TVA-SQN-TS-01-08

**SEQUOYAH NUCLEAR PLANT (SQN) - UNITS 1 AND 2 - TECHNICAL
SPECIFICATION (TS) CHANGE NO. 01-08, "INCREASE MAXIMUM
ALLOWED REACTOR POWER LEVEL TO 3455 MEGA-WATT THERMAL (MWt)"**

PROPOSED TECHNICAL SPECIFICATION (TS) CHANGE NO. 01-08 DESCRIPTION AND EVALUATION OF THE PROPOSED CHANGE

FIGURE 3.4-2 SEQUOYAH UNIT 2 REACTOR COOLANT SYSTEM HEATUP LIMITATIONS
APPLICABLE UP TO ~~16~~ EFY

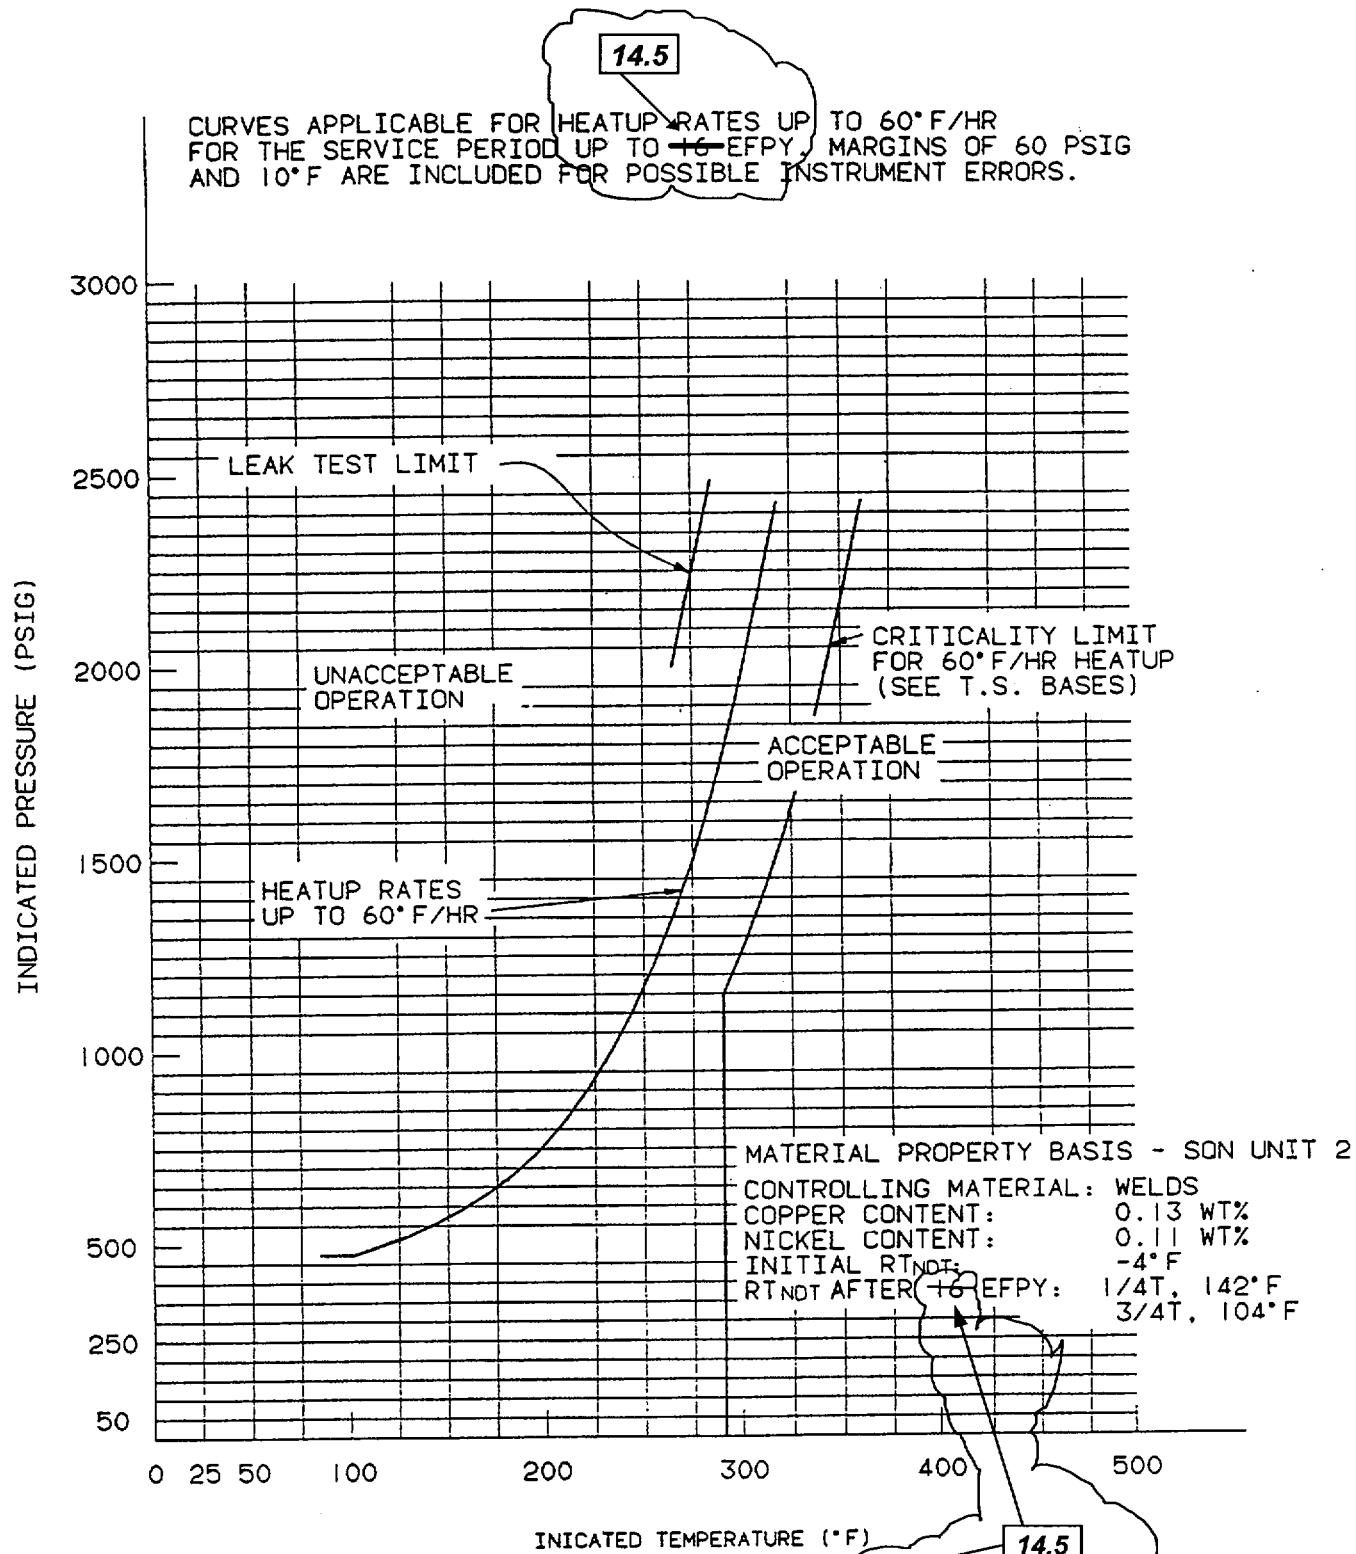
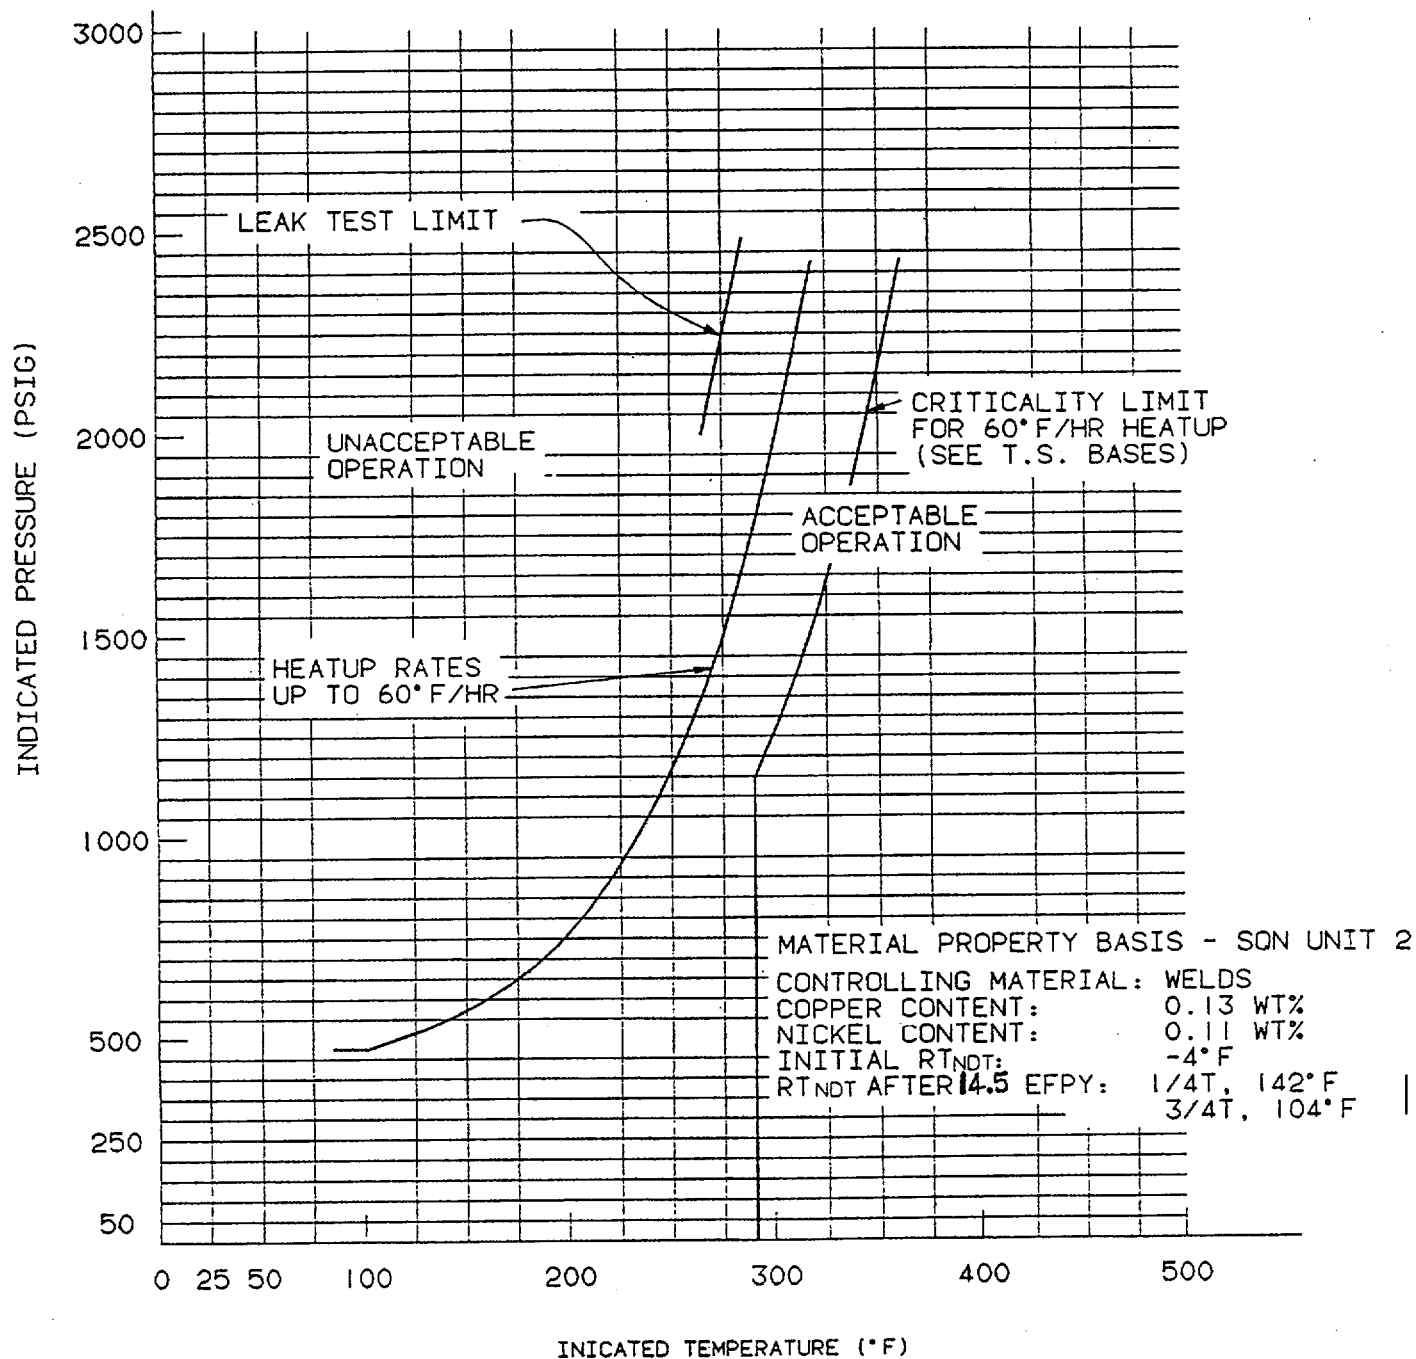
"RATED THERMAL POWER (RTP) shall be a total reactor core heat transfer rate to the reactor coolant of 3455 MWt."
- (3) TS Section 3/4.4.9.1, Pressure/Temperature Limits - Reactor Coolant System, Figures 3.4-2 and 3.4-3 for Unit 2 only are revised to change the effective full power year (EFPY) applicability from 16 EFPY to 14.5 EFPY. A corresponding change to the Bases has also been provided.
- (4) TS Section 3/4.4.12, Low Temperature Over Pressure Protection Systems, Figure 3.4-4 for Unit 2 only is revised to change the EFPY applicability from 16 EFPY to 14.5 EFPY.
- (5) TS Section 3/4.7.1.1, Safety Valves, Table 3.7-1, for inoperable steam line safety valves versus maximum allowable power range neutron flux high setpoint requirements is revised. With one inoperable main steam safety valve (MSSV) per loop, the setpoint is

The heatup and cooldown curves for Unit 2 are now applicable for 14.5 EFPY instead of 16 EFPY. The heatup and cooldown curves define limits that still ensure the prevention of nonductile failure for the SQN Units 1 and 2 reactor coolant system (RCS). The design-basis events that were protected have not changed. This modification does not alter any assumptions previously made in the radiological consequence evaluations nor affect mitigation of the radiological consequences of an accident described in the Updated Final Safety Analysis Report. Therefore, the proposed changes will not significantly increase the probability or consequences of an accident previously evaluated.

CURVES APPLICABLE FOR HEATUP RATES UP TO 60°F/HR
FOR THE SERVICE PERIOD UP TO 14.5 EFY. MARGINS OF 60 PSIG
AND 10°F ARE INCLUDED FOR POSSIBLE INSTRUMENT ERRORS.

FIGURE 3.4-2 SEQUOYAH UNIT 2 REACTOR COOLANT SYSTEM HEATUP LIMITATIONS
APPLICABLE UP TO 14.5 EFY

FIGURE 3.4-4

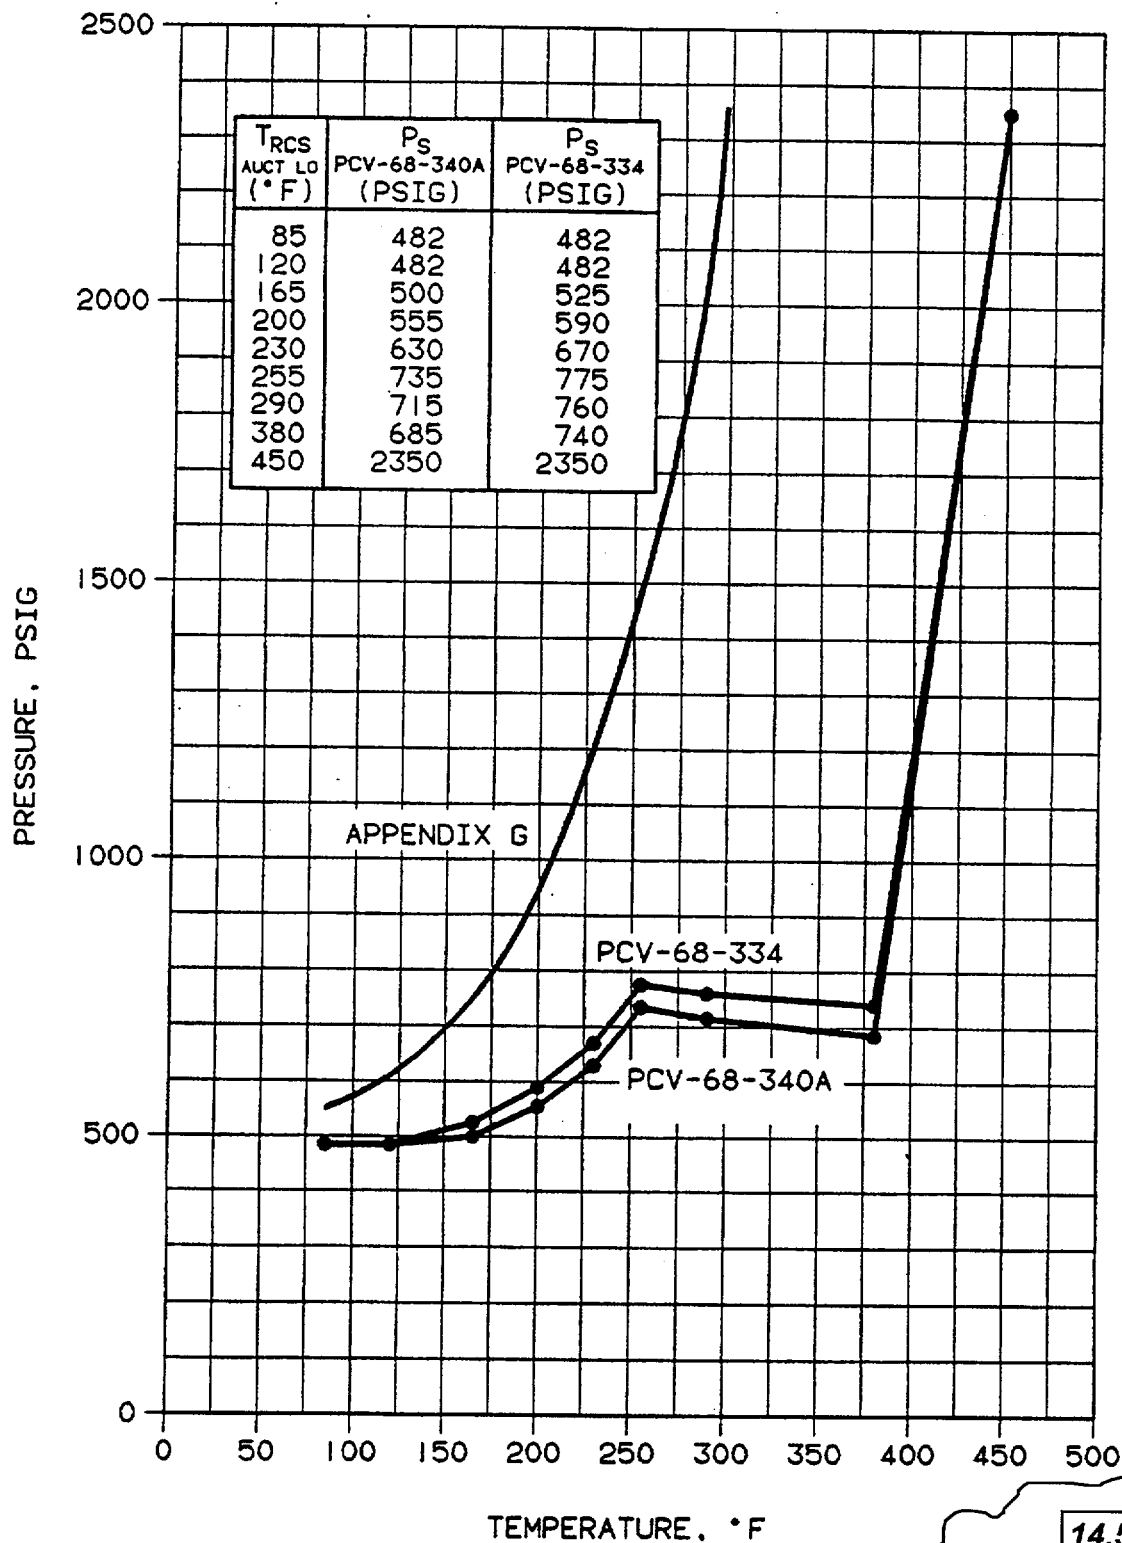
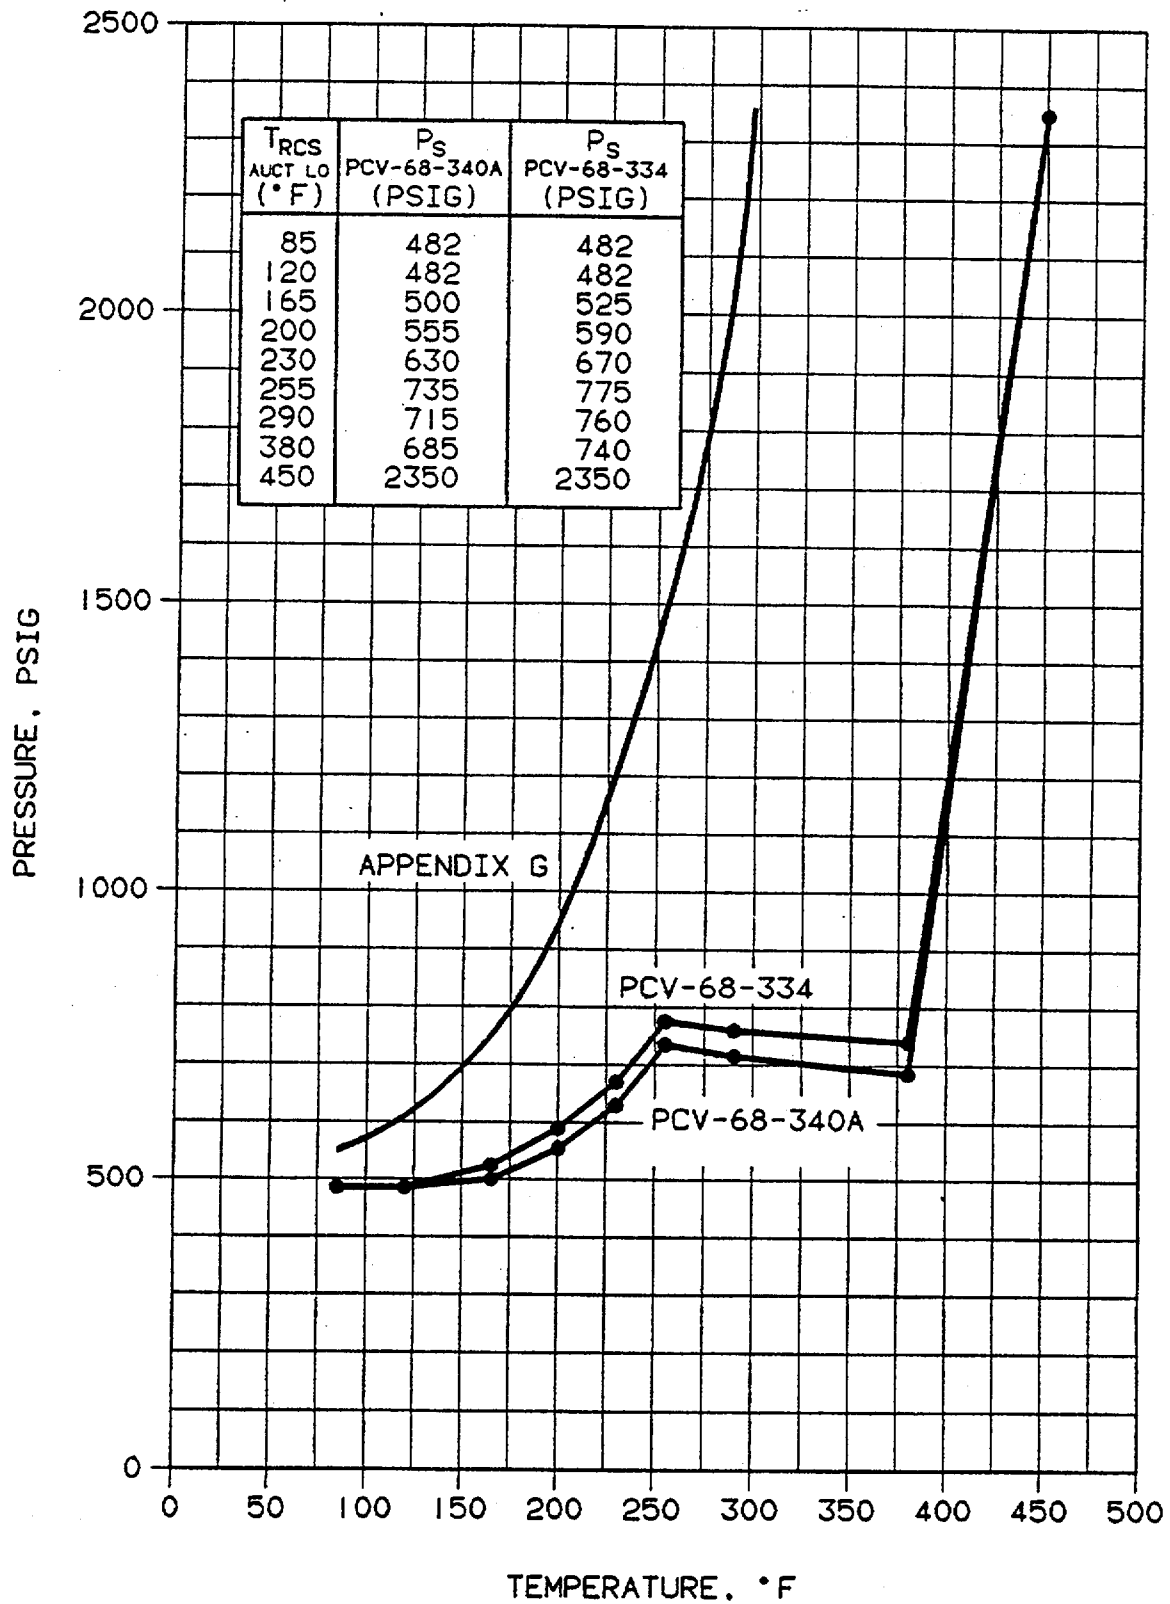
PORV NOMINAL LIFT SETTINGS - APPLICABLE UP TO +6 EFPY

PORV NOMINAL LIFT SETTINGS - APPLICABLE UP TO 14.5 EPFY
